Detailed Site Plan
Departure from Design Standards
Alternative Compliance
ALTA Woodmore

DSP-22034
DDS-22002
AC-23001

STAFF REPORT

SUBJECT: Detailed Site Plan DSP-22034
Departure from Design Standards DDS-22002
Alternative Compliance AC-23001
Type 2 Tree Conservation Plan TCP2-053-07-06
ALTA Woodmore

Figure 3: Proposed Building-Mounted Signage

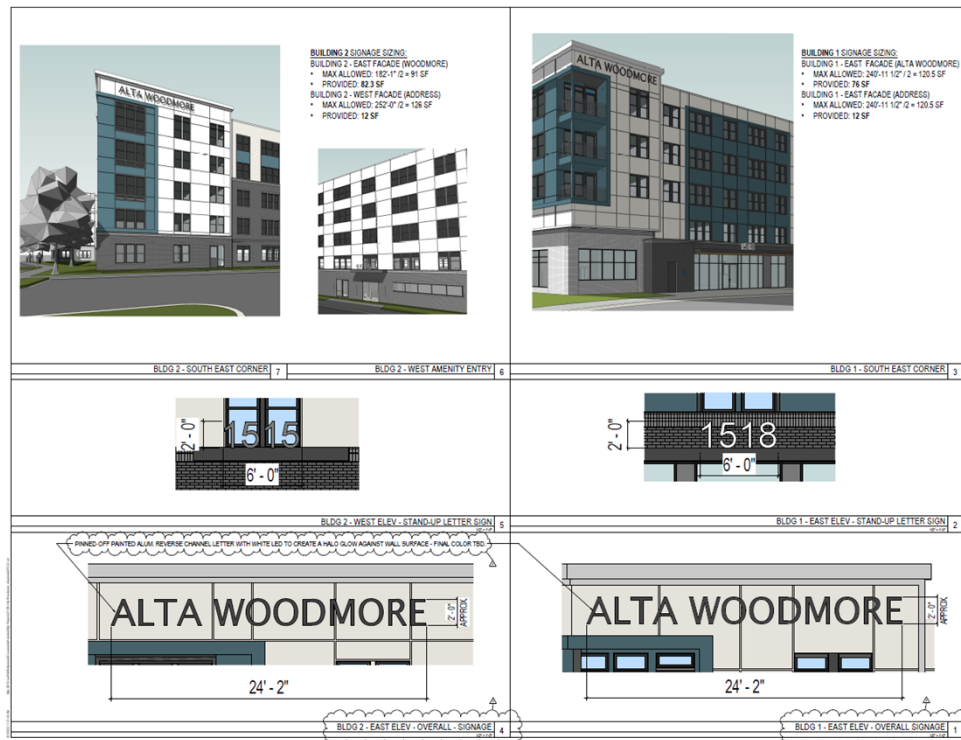
approximately 182 square feet of building-mounted signage that falls within the maximum square footage allowed under the C-S-C Zone and, therefore, the proposal is found to be reasonable and consistent with signage in other commercial zones throughout the County. As referenced earlier, conditions have been included herein, requiring the applicant to provide a signage schedule on the DSP coversheet, to revise the freestanding sign stand material from stone to brick, and provide attractive understory landscaping for the freestanding sign.
